### Town of Kittery Planning Board Meeting September 12, 2019

#### ITEM 2 – 76 Dennett Road – Site Preliminary Plan Review

Action: Approve with or without conditions, continue consideration of or deny plan. Owners William J. Cullen and Sail Away, LLC and applicant William Wharff request consideration of a mixed-use residential development on 23.3+- acres of land at 76 Dennett Road (Tax Map 6 Lots 15B & 16A and Tax Map 13, Lot 4) in the Mixed Use - Neighborhood (MU-N) Zone. Agent is Shawn Tobey, P.E. Hoyle, Tanner & Associates, Inc.

# **BUILDING 2 GROUND FLOOR**

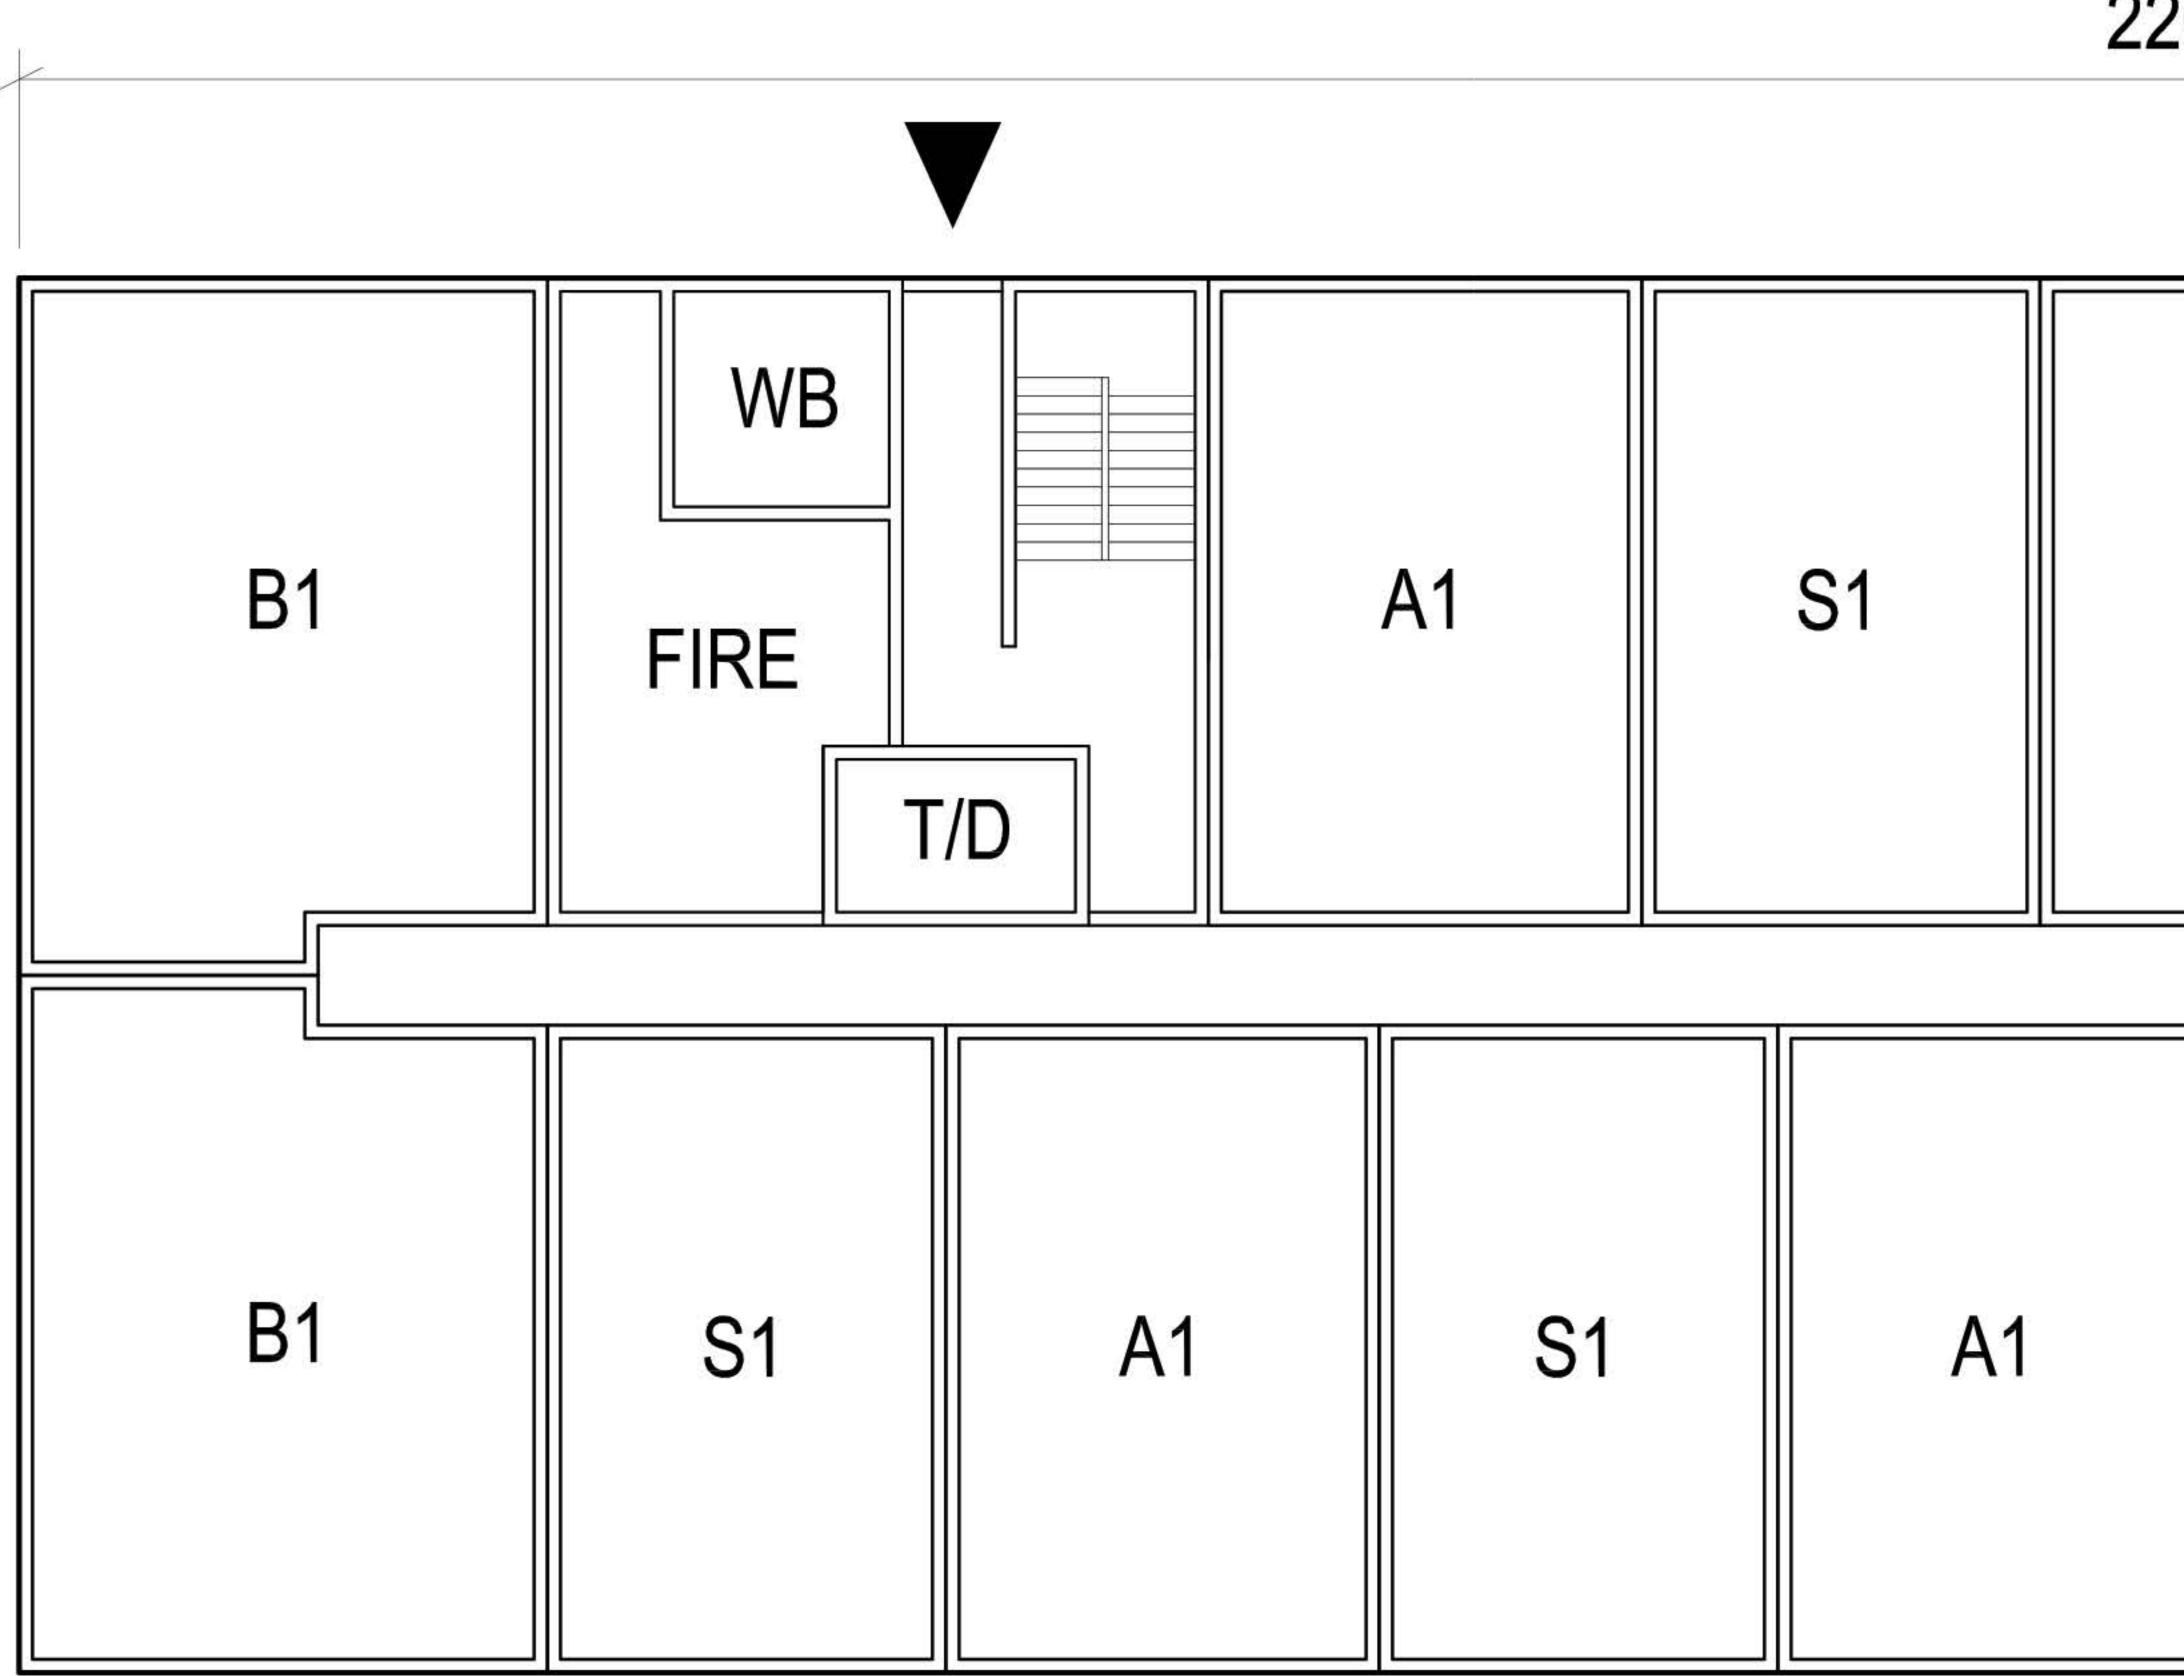
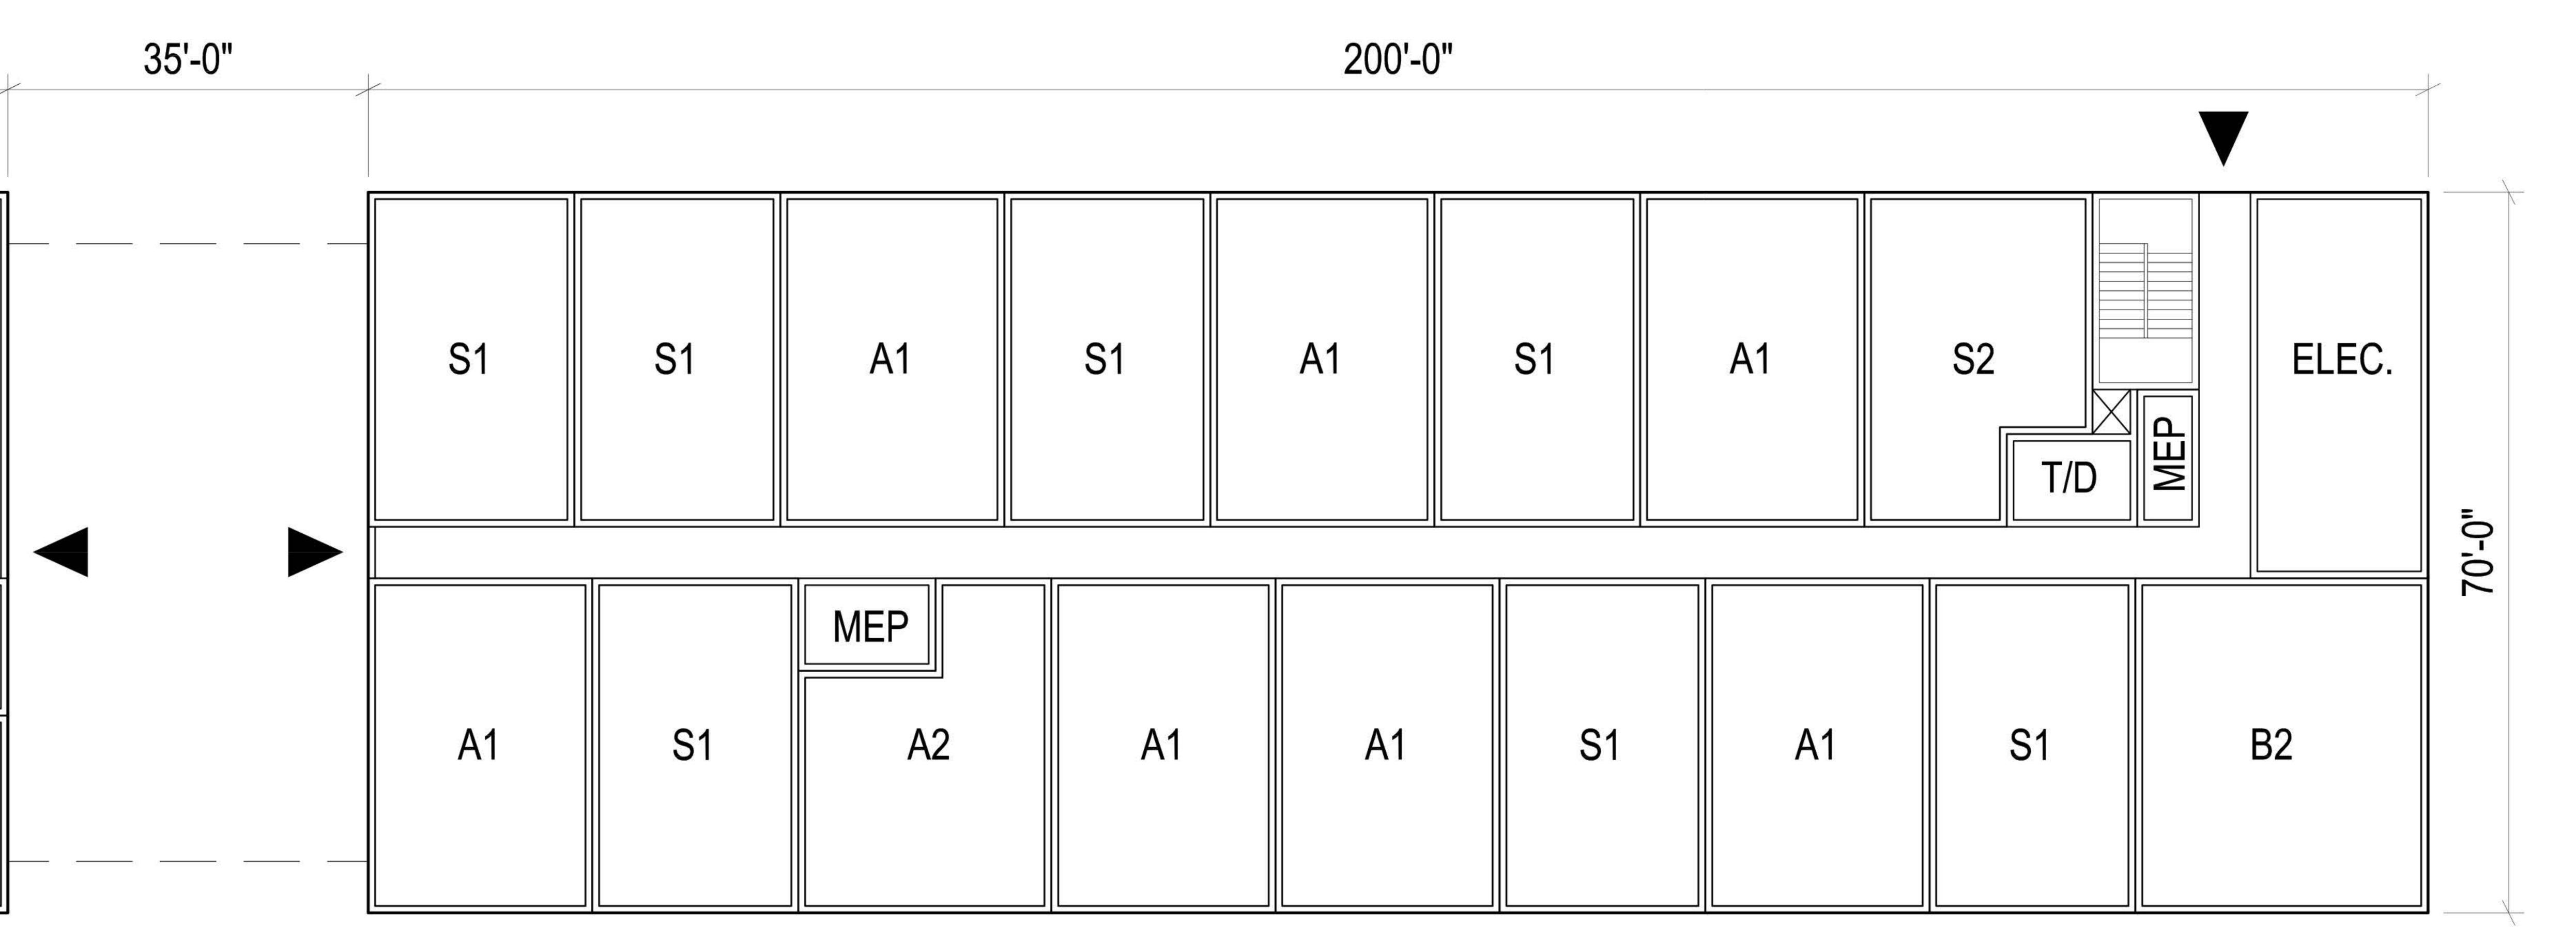
- 2. The Conceptual Floor Plans shall be revised to indicate that the studio apartments will contain a minimum of 650 sf of habitable space;
- 3. Completion of a third-party review of the proposed landscaping plans;
- 4. Provide details of the proposed sidewalk for the full length of the property for Final Plan review; and,
- 5. Address to the satisfaction of CMA Engineers their 2<sup>nd</sup> round of plan review comments.

- All studio units were revised to be a minimum of 650 SF.
- A legend was added.
- Dimensions depicting building heights were added to the elevations
- Building material callouts were added to the elevations.
